BOARD OF COUNTY COMMISSIONERS  
ORANGE COUNTY, FLORIDA  
ADDENDUM NO. 1/ IFB Y17-732-EB

ORANGE COUNTY CORRECTIONS VIDEO VISITATION PARKING LOT  
IMPROVEMENTS

LP3.1

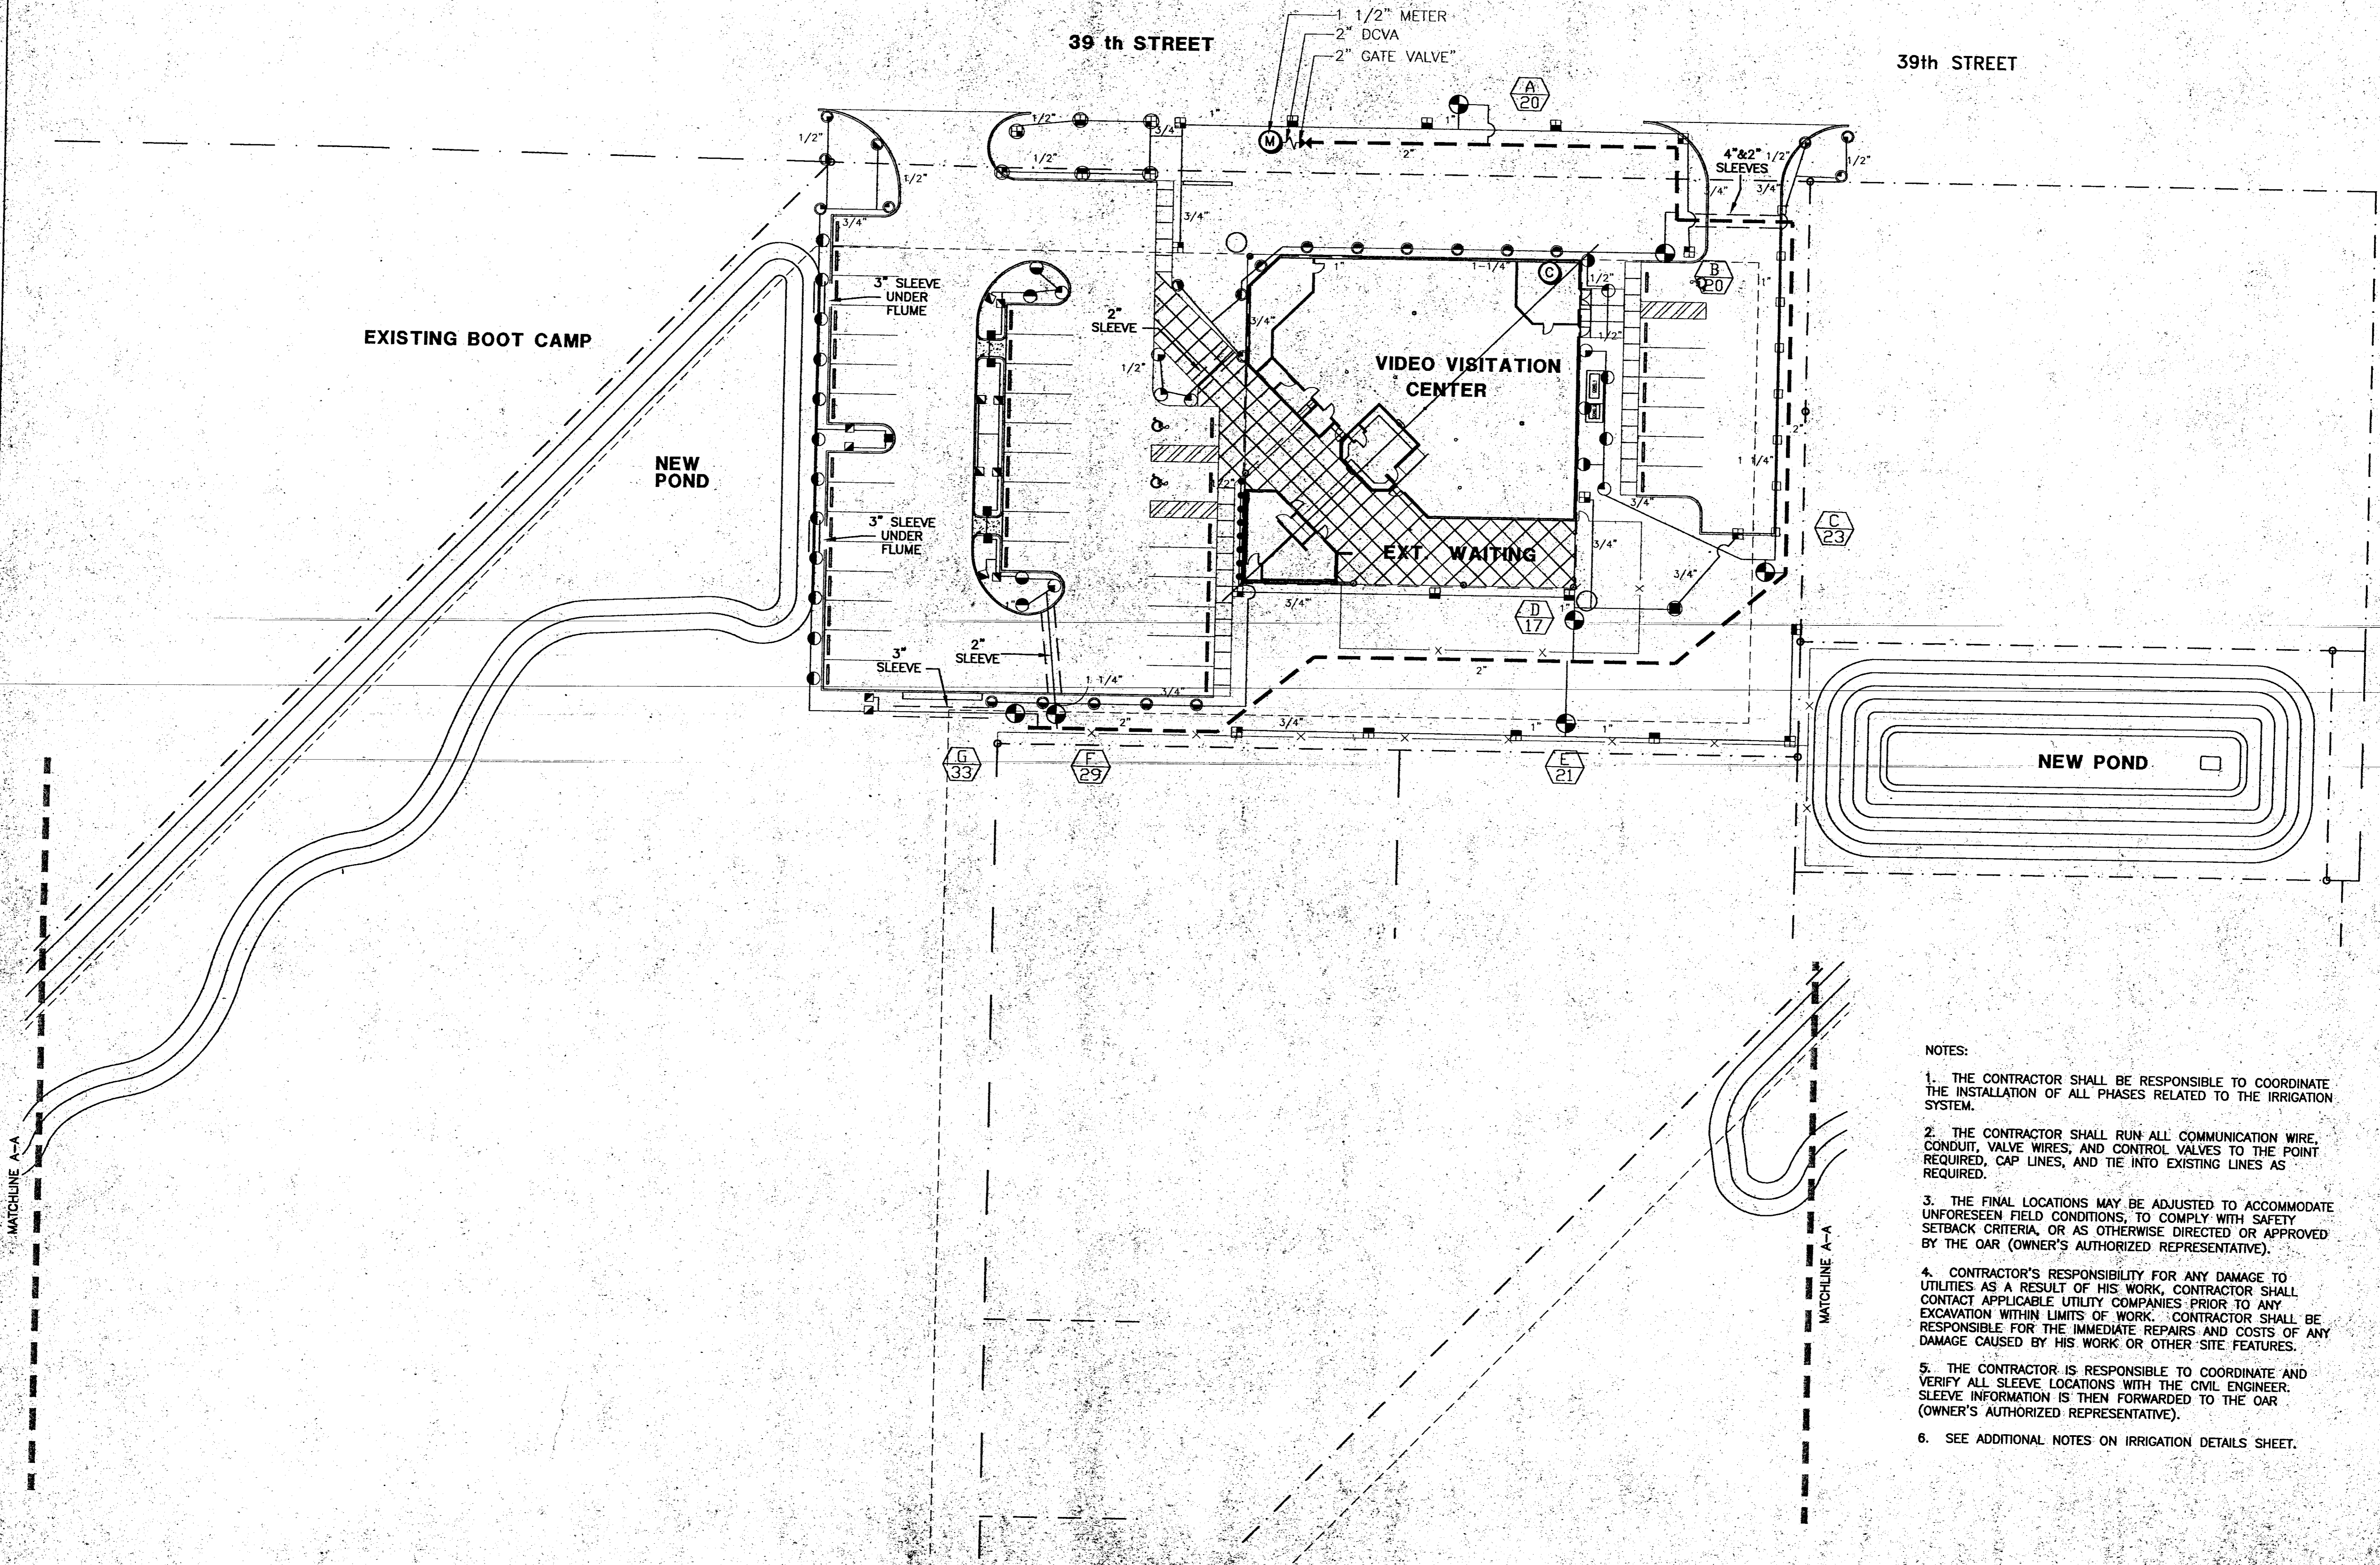
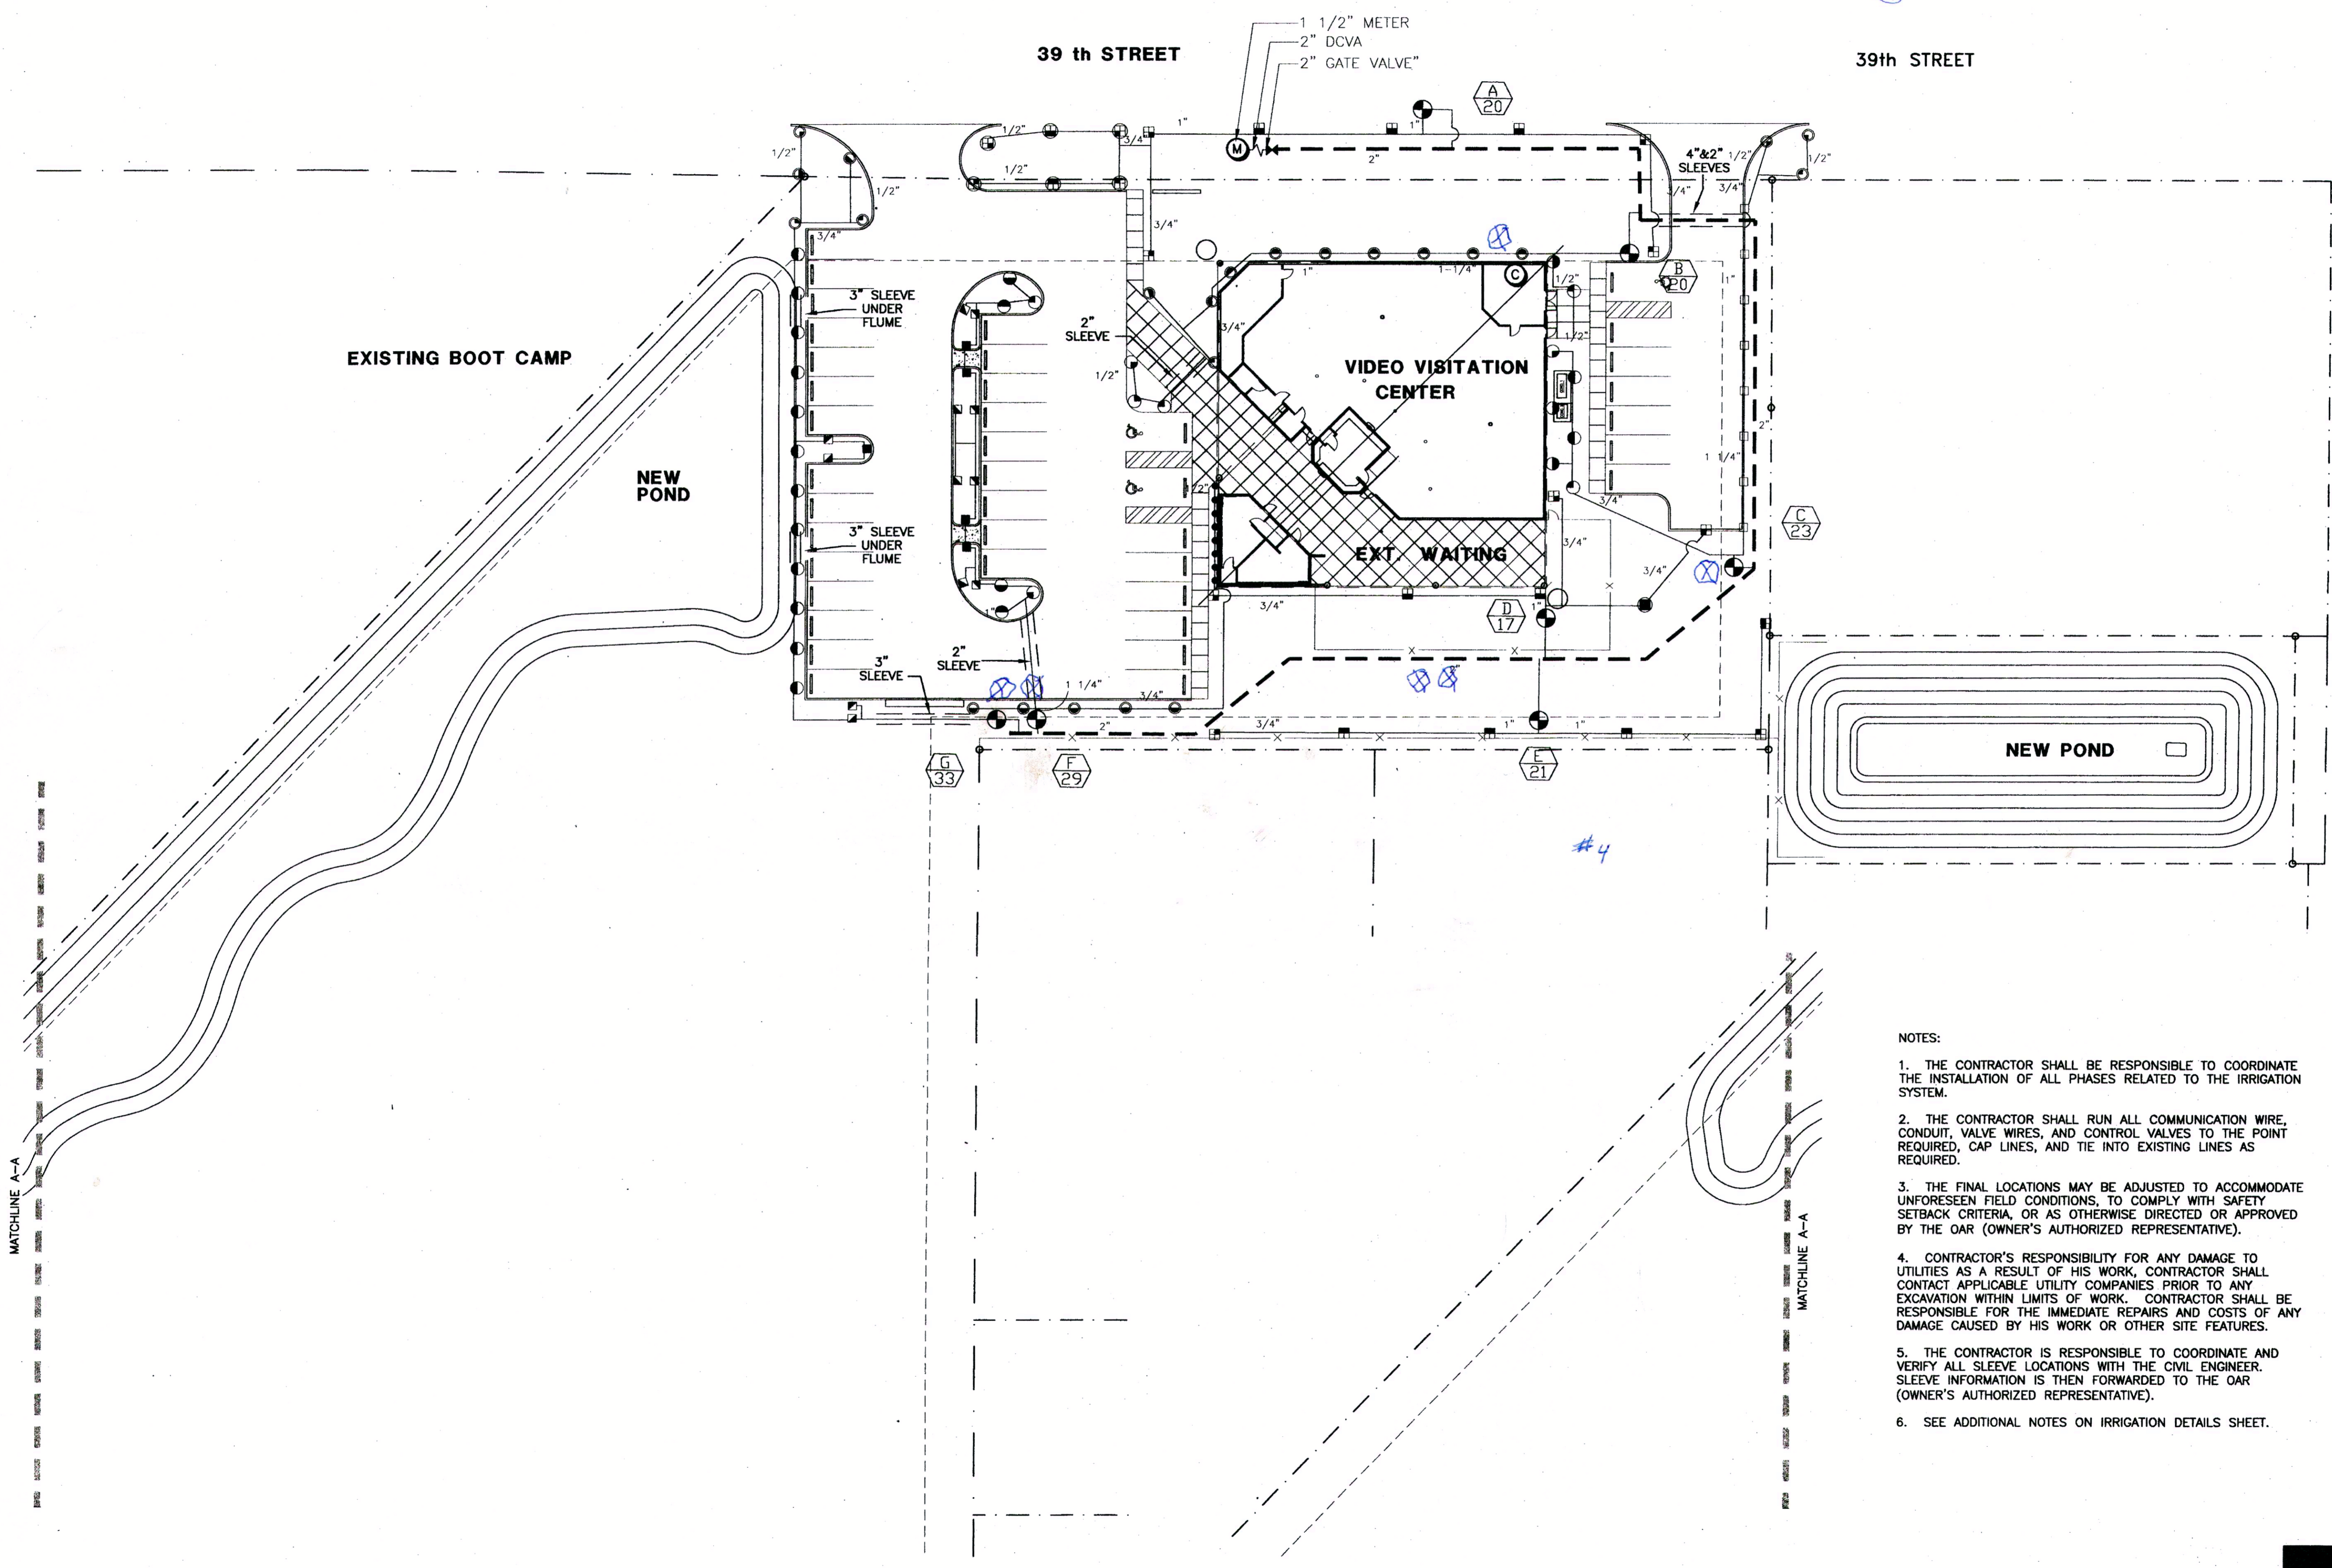
8. **Question:** During the pre-bid walk through we noticed at least six underground valve boxes, several irrigation heads, and several underground electrical boxes in this work area. Does Orange Co. have existing as-built showing the locations of the various underground infrastructure? **Answer:** Refer to attachments.
